A REVISION TO:
PRELIMINARY OVERALL
DEVELOPMENT PLAN
#268/M.D.P.
ENCINO PARK

VILLAGE AT STONE OAK
SAN ANTONIO, TEXAS

City of San Antonio
Development Services Department
Master Development Plan
APPLICATION

City of San Antonio
Development Services Department
Master Development Plan
REQUEST FOR REVIEW

SHEET
1
OF 1

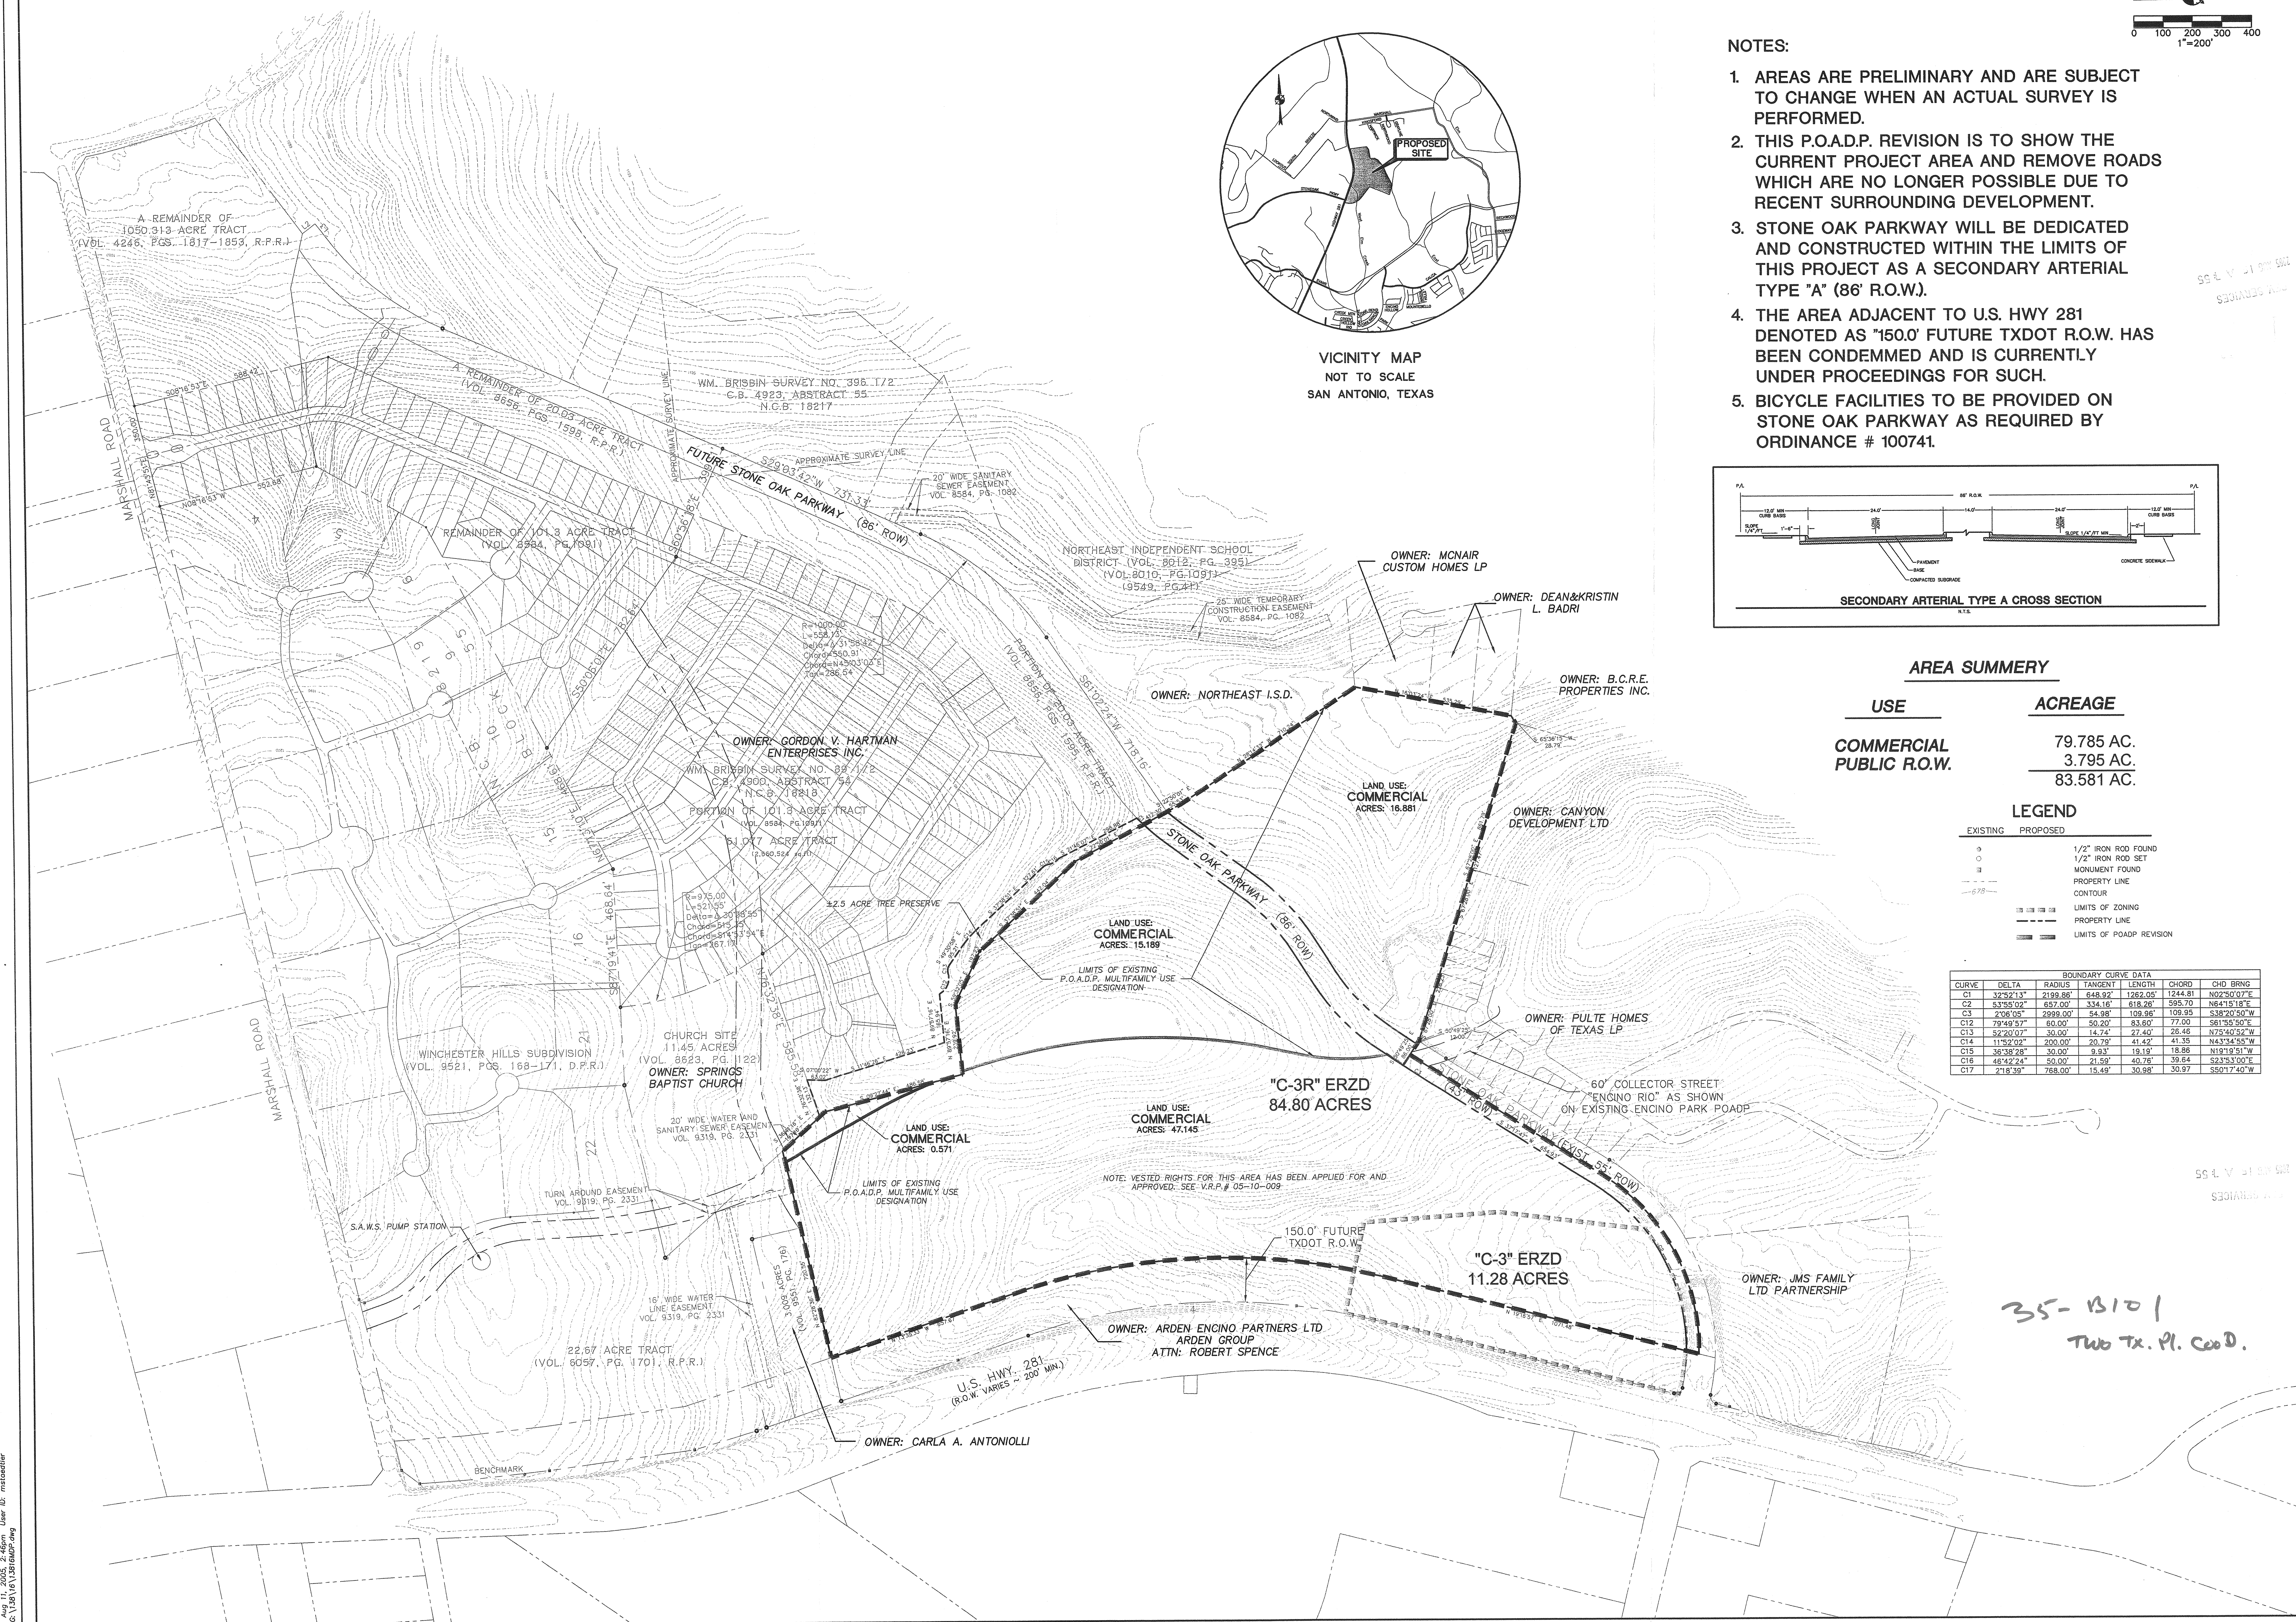
- ANNOTATE MOP PERIODIC LIMIT
- TWO TX. PLAN COORDINATES
- IDENTIFY AREA OF VESTING
- NEED LOCATION

Proposed plan need to address UDC 35-B101
Annotate MDP boundary limits
Identify area of vesting
Need location map

**SHEET
1
OF 1**

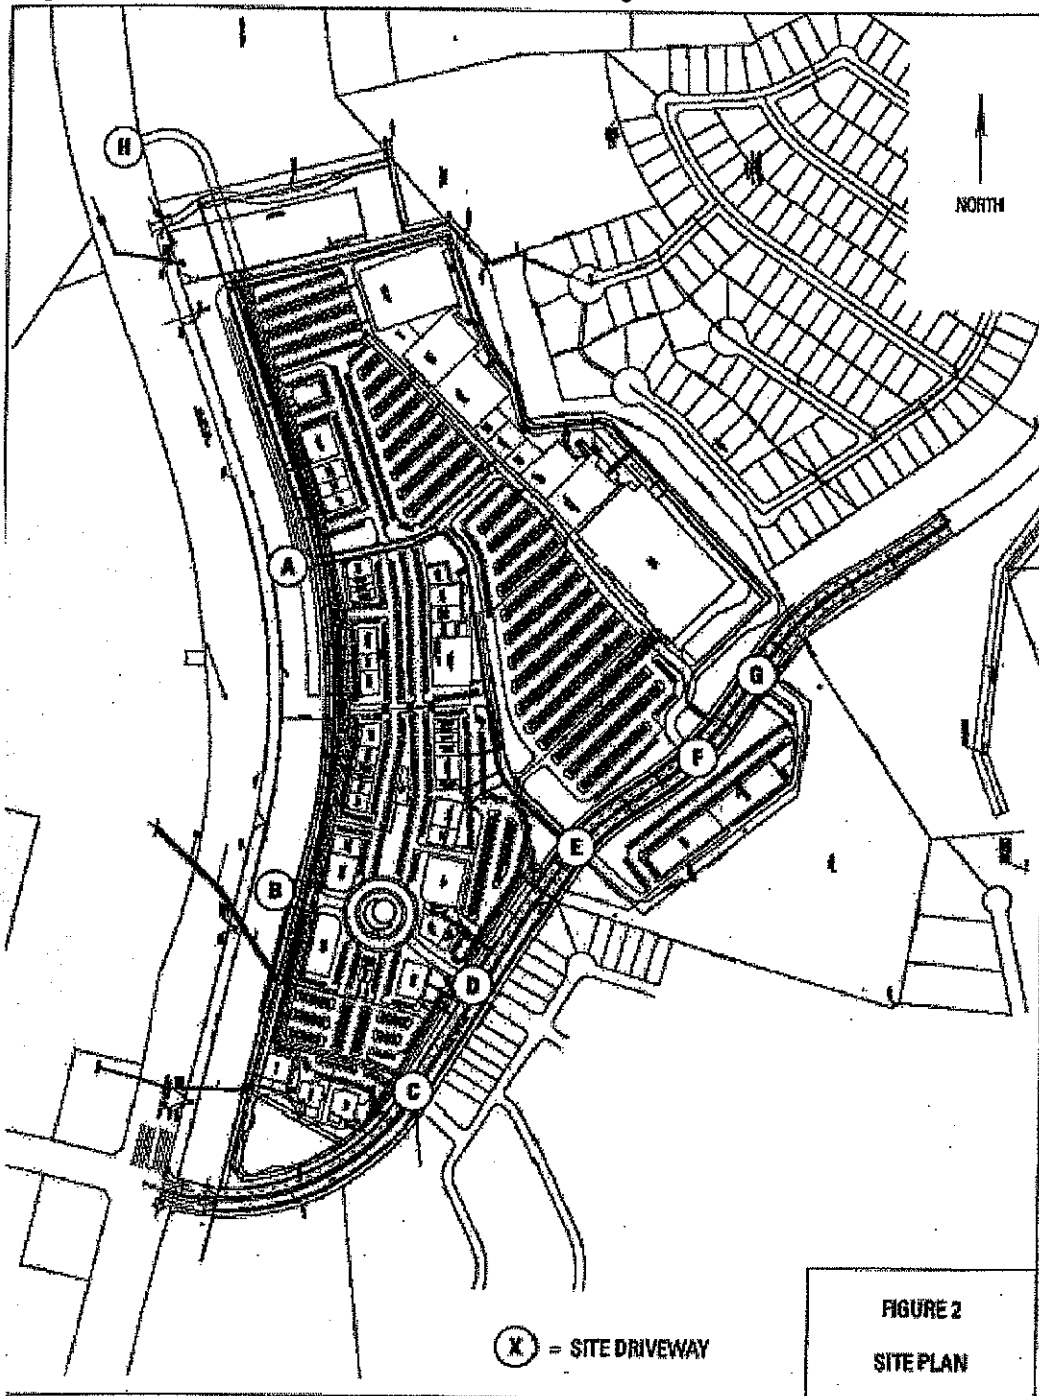
PLEASE ADD A 'GENERAL NOTE' TO PLANS STATING THAT
SIDEWALKS WILL BE INSTALLED IN THE PUBLIC RIGHT-OF-WAY
PER UDC ARTICLE 5, DIVISION 2: 35-506(q.)

Also include a cross-section profile view of the street showing width
and placement of sidewalk.

Zoning: Approved with a condition that the zoning labels on the MDP be changed to reflect the current zoning, i.e. change the "B-3" ERZD and "B-3R" ERZD labels to the current names: "C-3 ERZD" and C-3R ERZD".
